**Tree Inventory, Assessment,
and
Protection Report**

**16724 Chirco Avenue
Los Gatos, CA 95032**

Town of Los Gatos

February 25, 2025

A2: Site Plan and Proposed Tree Protection

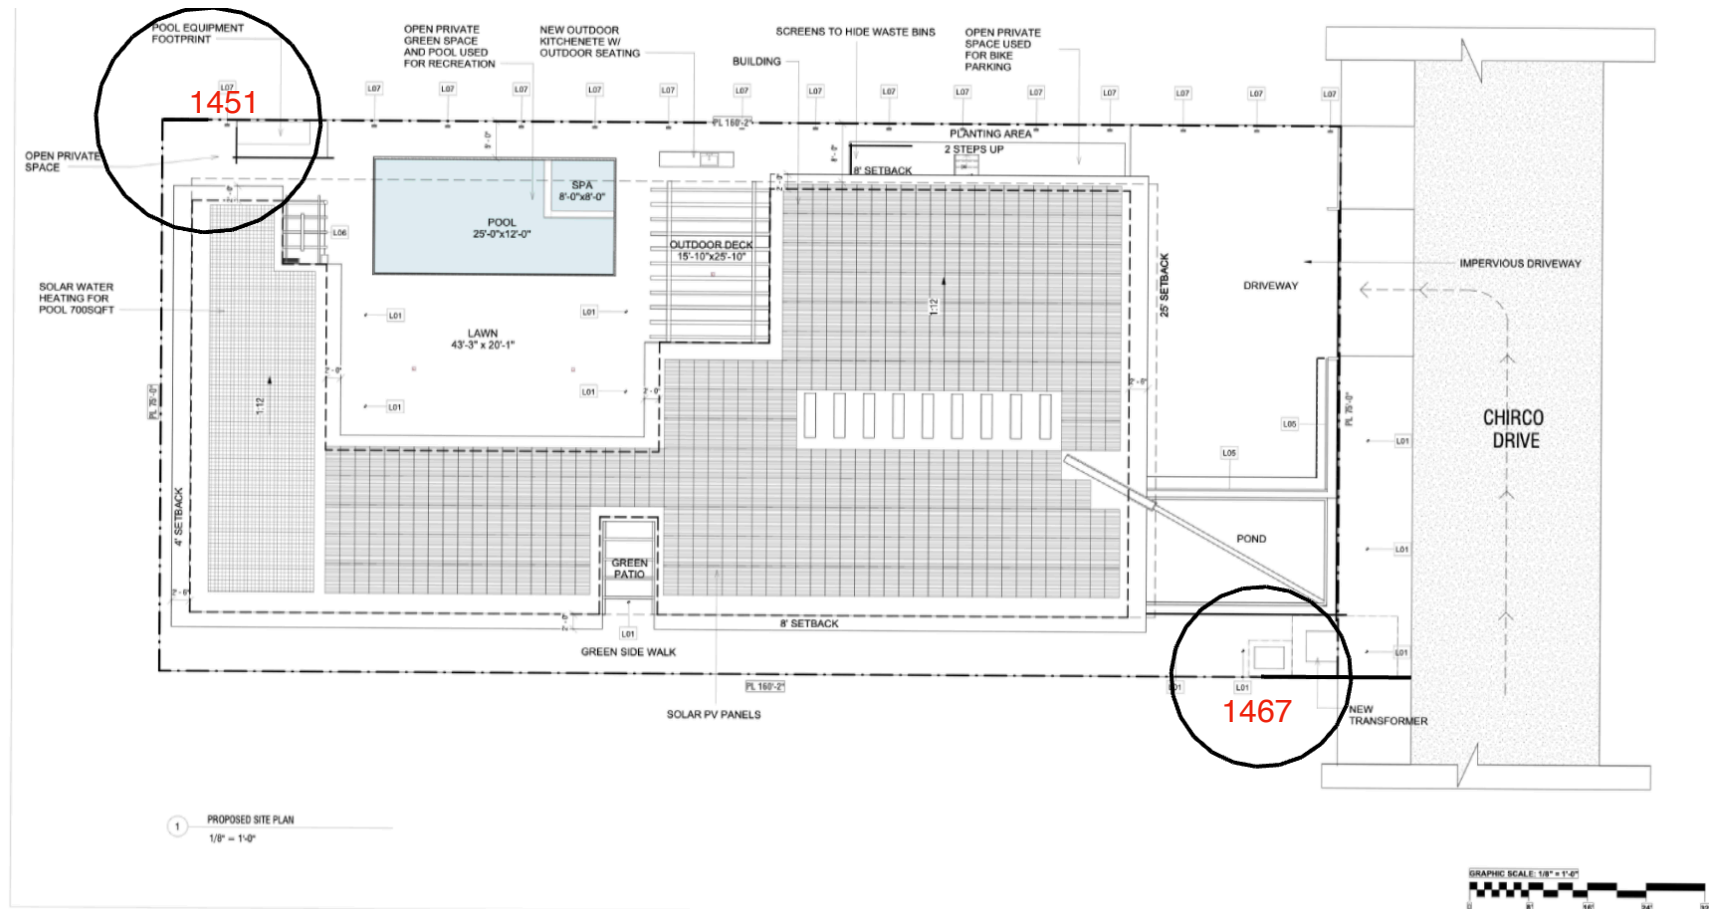
1. Place tree protection fence around the trees to be retained as specified in Appendix A.
2. Locate coast live oak #1451 and London plane #1467 accurately on the site plan. Move facilities as necessary to reduce impacts within the calculated tree protection zones, establish protection fence or have the arborist establish new tree protection specifications for trees to be retained.

The large circles indicate the calculated tree protection zones around trees 1451 and 1467 (Locations are estimated).
